**STAFF REPORT  
GREENFIELD PLAN COMMISSION  
TUESDAY, FEBRUARY 12, 2019  
6:30 PM**

**ROOM 100 – CITY HALL – 7325 W. FOREST HOME AVE., GREENFIELD, WI 53220**

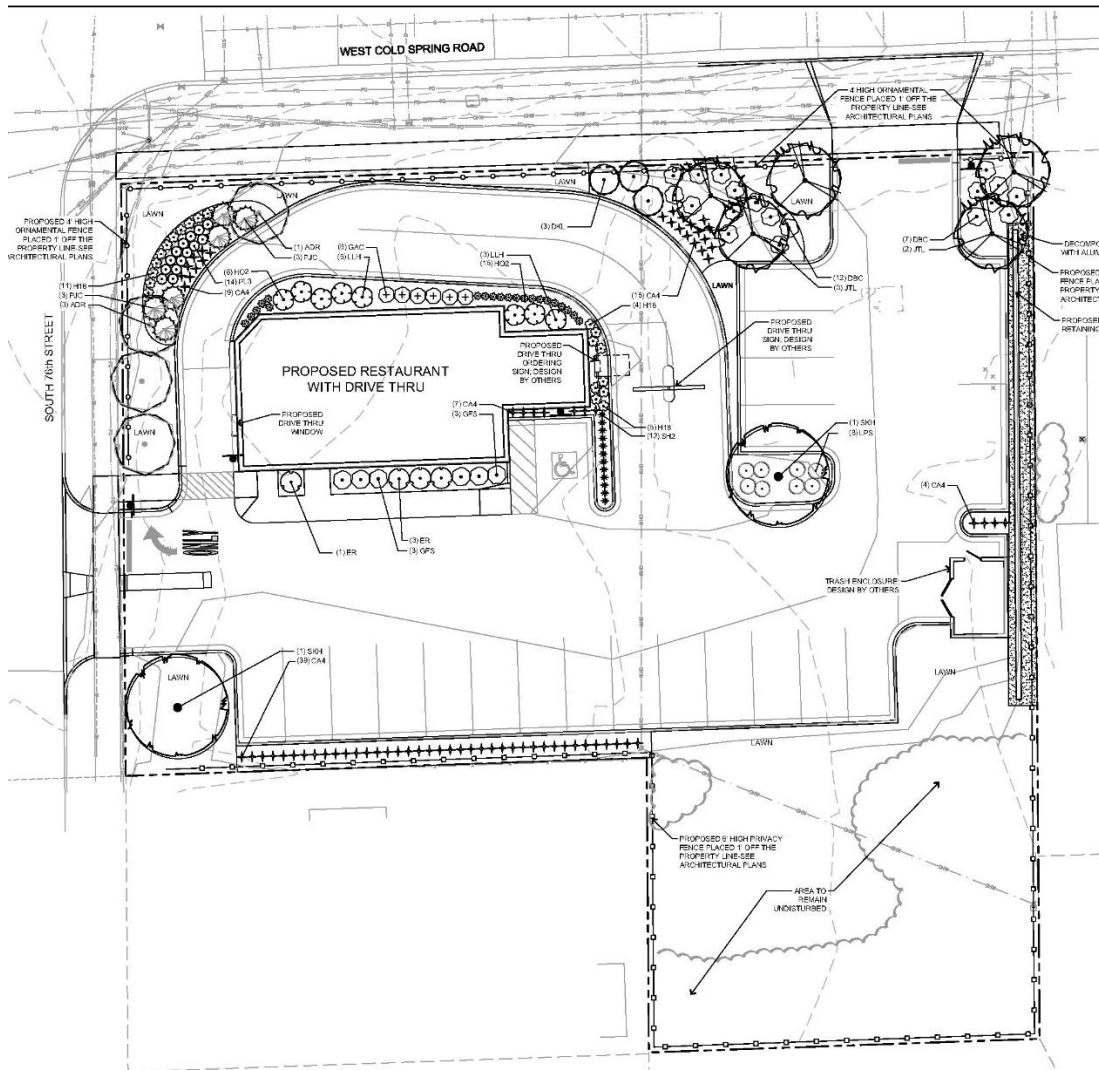
As part of the development, the proposal includes the removal of the existing driveways (one on each street frontage) and installation of one right-in/right-out driveway on S. 76 St. and one driveway on W. Cold Spring Rd. Since S. 76 St. is a County road with a bus stop, the developers have reached out to the responsible agencies with the proposal. Preliminary coordination with Milwaukee County Transit System and Milwaukee County Department of Transportation has resulted in favorable opinions about the proposed work.

The development is seeking an approval from the departure of the zoning ordinance for the minimum building setbacks, and the number of provided off-street parking spaces. Staff believes that the departure from building setback requirements will be consistent with the intent of the ordinances and will fit well with the neighboring commercial uses. Based on similar stores with a drive-thru facility, the developer, who has built several of the same uses, believes that the amount of parking spaces provided will be adequate for this use. Approximately 50% of patrons choose to use the drive-thru lane, thereby reducing the need for off-street parking and reducing time that customers spend on the property. The Municipal Code requires 20 off-street parking spaces/1,000 sq. ft. + 7 stacking spaces for the drive-thru, which amounts to 30 off-street spaces for a 1,500 sq. ft. limited service restaurant. The proposed site plan provides 21 off-street parking spaces and stacking for 14 vehicles in the double-lane drive-thru. The Common Council may waive the 9-stall parking shortage.

Staff has worked with the developer on some site alterations, including the S. 76 St. right-in/right-out curb cut, and a continuation of a raised concrete curb/island that would prohibit vehicles that are existing the drive-thru, to exit the site and try to head southbound on S. 76 St. Existing vehicles would be forced to turn right, or northbound onto S. 76 St., or would be forced to exit onto W. Cold Spring Rd.

1. Revised Site, Landscaping and Architectural Plans being submitted to the Community Development Division to show the following: (a) refuse enclosure elevations; (b) all fence type cross-sections; (c) retaining wall cross-sections; (d) alternate grease trap location away from the drive-thru lane; (e) modified landscaping plan that considers the

steel door location on the south side of the building, that includes taller plant materials to conceal the freezer/cooler, and any other modifications at the recommendation of the City Forester; and, (f) building light fixture details.

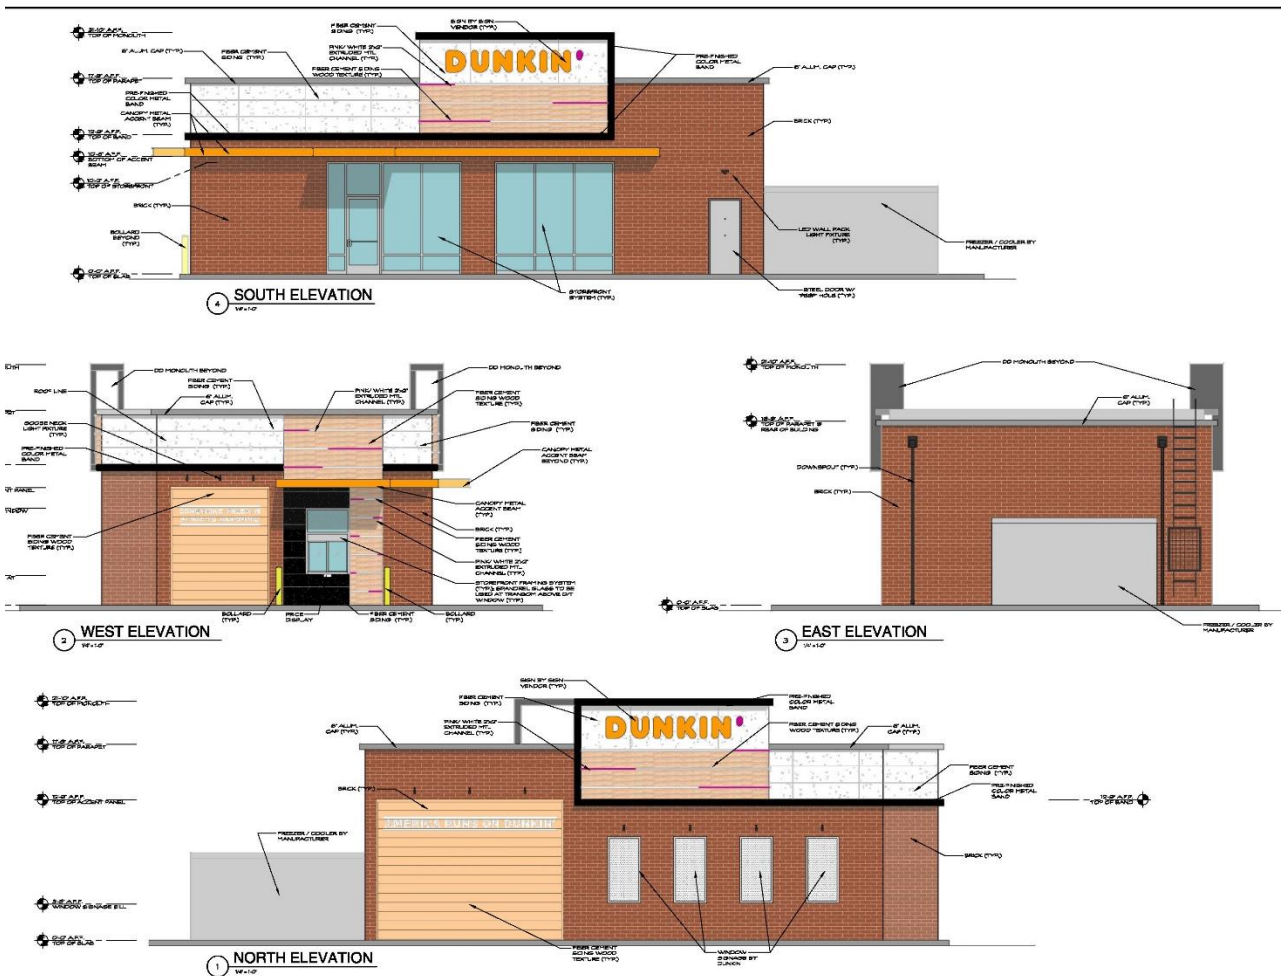
The site perimeter will include a 6-ft. high cedar fence along the south and east property lines, and a 4-ft. high decorative aluminum fence along W. Cold Spring Rd. and along S. 76 St., north of the driveway. The 4-ft. decorative fence is intended to keep pedestrians from entering and crossing the drive-thru on the north side of the site. A retaining wall will be constructed along the east property line. The engineer is working on the wall specs, but its highest point will be approximately 24" in height and will taper down towards the north and south sides of the wall.

A four-sided brick refuse enclosure will be constructed at the southeast corner of the parking lot. The enclosure will include cedar wood doors and a personnel door for employees to use.

The one-story Dunkin' Donuts building will be constructed mostly with an earth tone brick. The top portion above the cornice, will be constructed of two different-looking fiber cement siding materials. The cornice, dividing the brick from the fiber cement materials, will be constructed of a pre-finished black colored metal band. A yellow-colored metal canopy accent beam will be included on the south and west elevations. The proposal includes a section of wood texture fiber cement siding on the west and north elevations. These blank rectangular-shaped features seem out-of-place and staff recommend that they be removed from the architectural proposal. The north elevation also includes four (4) display windows for signage. These are true windows with walls behind them that open from the outside (casement style) for graphics to be inserted in to. These casement style window fixtures may be considered part of the architecture of the building and not signage. The south, west and north elevations include pink and white 2" x 2" extruded metal channel pieces as a decorative accent. The metal channel pieces will be located on the vertical fiber cement surrounding the drive-thru window and around the two (2) wall signs on the north and south elevations. The south building elevation includes five (5) large storefront windows and the main building entrance door. The east elevation includes a freezer/cooler. Staff recommends a revised landscaping plan that includes taller plant materials will help conceal the metal cooler.

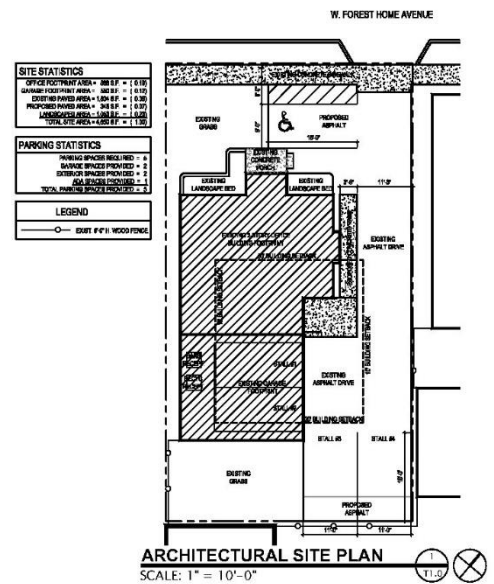
Home Path is proposing the following parking configuration: one (1) new ADA stall in the front of the property, which would result in a loss of open space; two (2) parking spaces within the existing garage; two (2) parking spaces in the rear paved surface. The parking configuration will be challenging, working with the existing layout for a single-family home. With the addition of the ADA ramp along the east side of the building, the drive aisle will be reduced to 11' 3", which doesn't meet the City's code requirement of 12' for one-way traffic and 24' for two-way traffic.

The proposed parking locations would not meet front yard and rear yard setback requirements and would require Zoning Board of Appeals approval.

FRONT ELEVATION

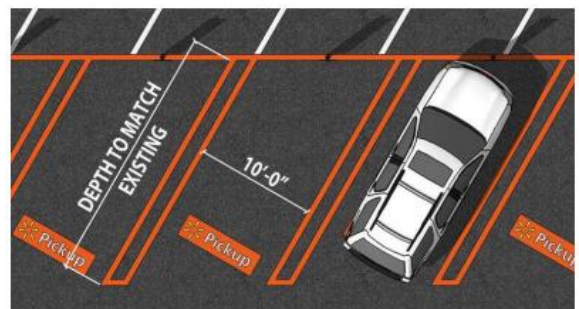
The proposal includes painting the current earth-tone brown EIFS upper middle section of the front façade with a gray paint and replacing the current earth-tone brown film panels with gray and blue panels behind the Walmart sign. In addition, Walmart is proposing to paint a portion of the northwest corner of the building, which is currently an earth-tone tan color, with orange paint, identifying “Pickup” as a new amenity to the store.

Walmart’s project description identifies the reasoning for the proposal as being a branding initiative. Bright blue and orange colors are intended to dominate the visual character of the building, which contradicts the City’s Site Development Standards identified above. Staff does not recommend approval of any of the painting or building color modifications that are proposed. This Walmart was built less than three (3) years ago in 2016 and Walmart’s proposal at the time met the City’s Site Development Standards. Staff does not recommend any deviation from the original architectural design of the building.

1. A new signage proposal that eliminates any exterior building façade alterations.
